**ALERT SERVICE BULLETIN**

407-00-36

**Bell Helicopter** **TEXTRON**

**SUBJECT:** 170 AMP MAXIMUM CONTINUOUS ELECTRICAL LOAD LIMIT FOR OPERATIONS ABOVE 10,000' DENSITY ALTITUDE, INTRODUCTION OF.

**Figure 2. Instrument Reidentification**

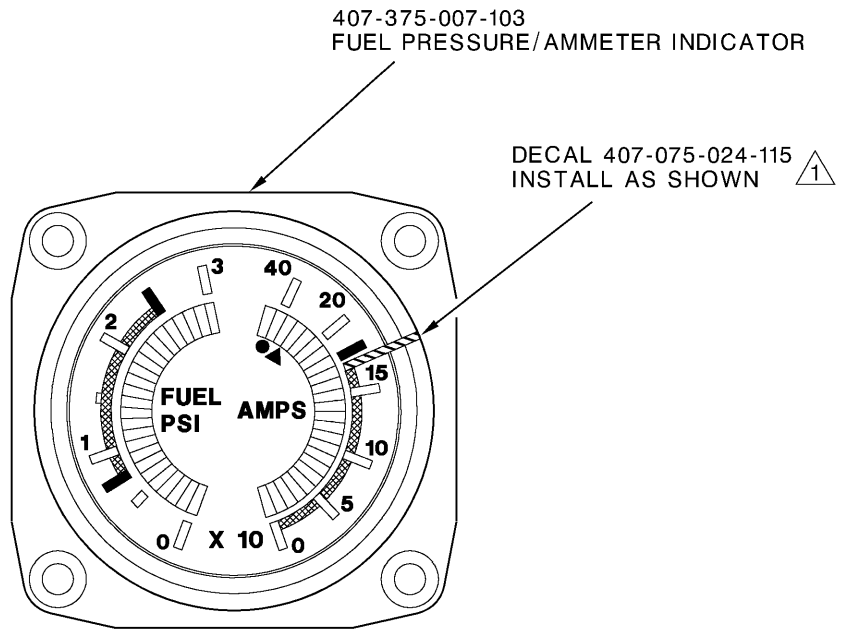
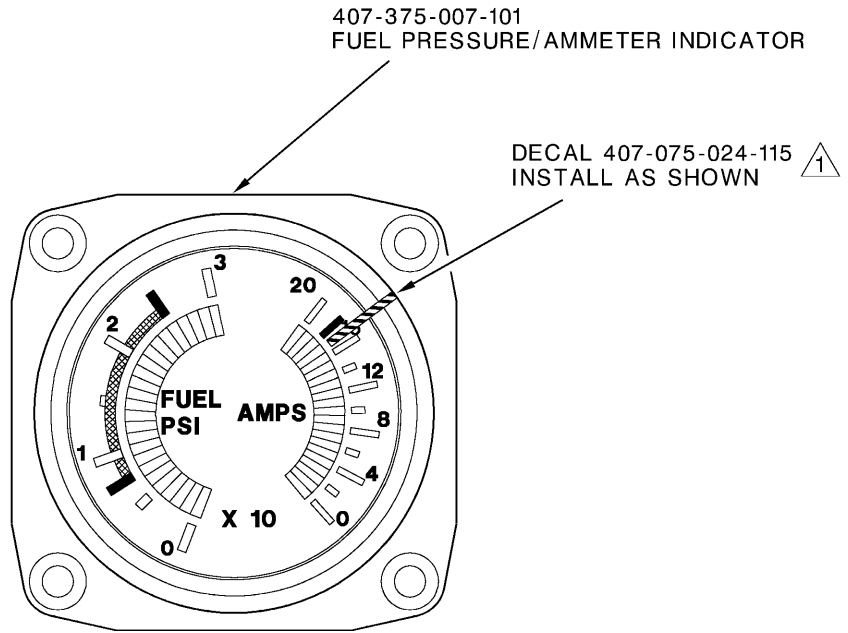
7. Peel off protective backing from notated identification plate and adhere to instrument as shown in figure 2.
8. Using a ballpoint pen, put a line through the P/N 407-375-007-101 or -103 displayed on the indicators original data plate.
9. Install modified Fuel Pressure / Ammeter indicator to instrument panel with 4 screws. Install electrical connector to indicator.

- 1 Reidentification plate P/N 100-088-1 is provided blank
  - Prior to installation, notate plate as shown for applicable indicator with ball point pen.
  - Use sufficient pen pressure to indent notation on plate.
  - Include existing serial number of indicator in space provided.
- 2 After plate has been notated, peel off protective backing and install plate on instrument in location shown.
- 3 Use ball point pen to put single line through original part number of indicator in location shown.

**Figure 1. Addition of Decal at 170 Ampere Position on Indicator**

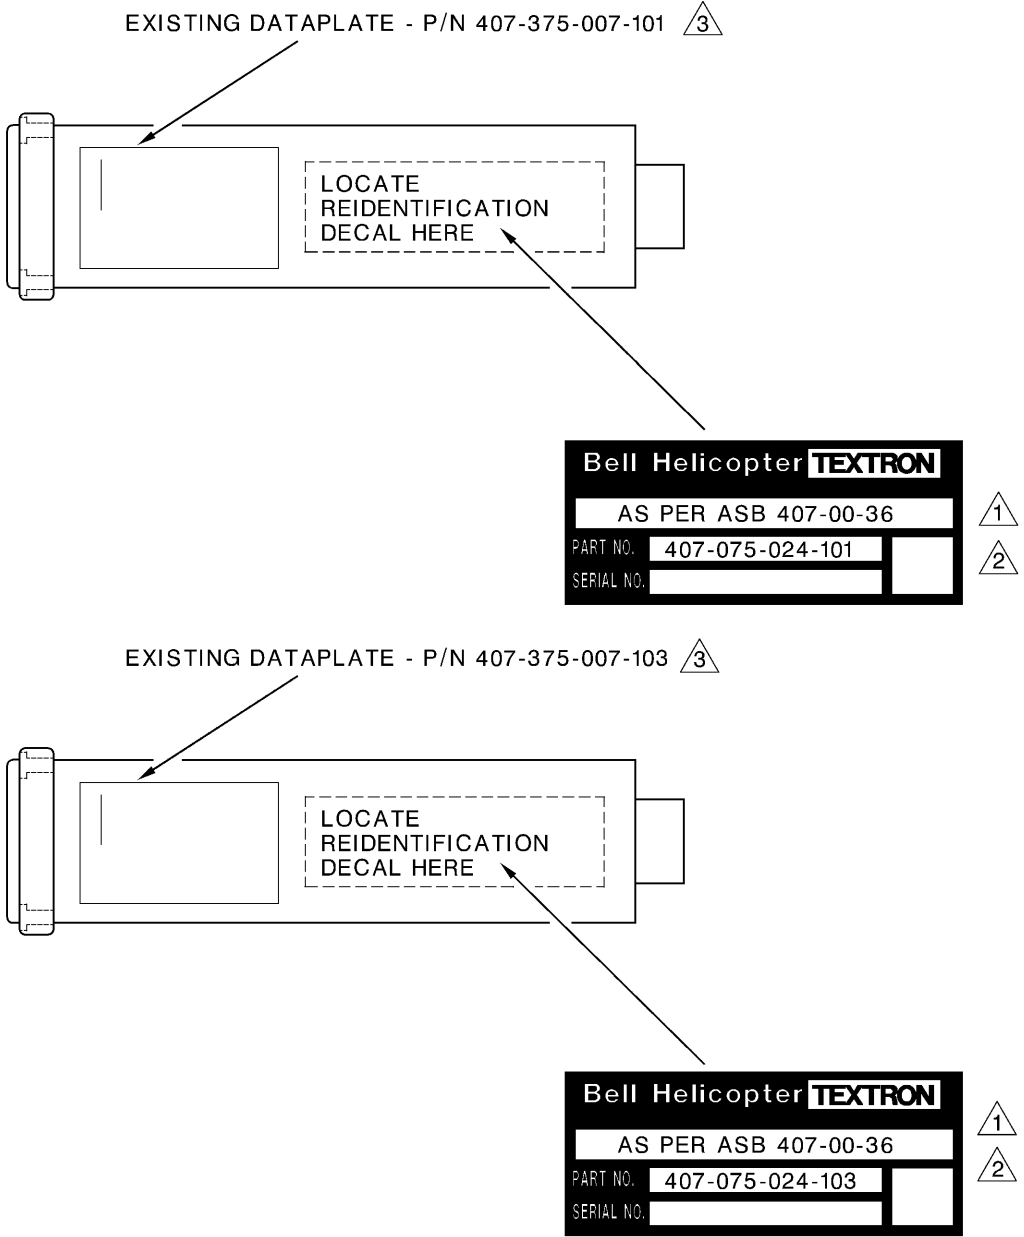
5. Being careful not to touch the cleaned glass cover and bezel of indicator with fingers, apply decal P/N 407-075-024-115 to P/N 407-375-007-101 or -103 indicator as shown in Figure 1. Apply decal on the glass cover and bezel of the indicator, over the 170 ampere position. Once decal is confirmed to be located in the proper position use finger pressure to ensure decal is securely adhered.
6. With reference to Figure 2, use a ball point pen to notate identification plate P/N 100-088-1 as shown. The notated 100-088-1 plate will be used to reidentify the indicator to P/N 407-075-024-101 or -103.

Install decal in appropriate position for indicator part number.
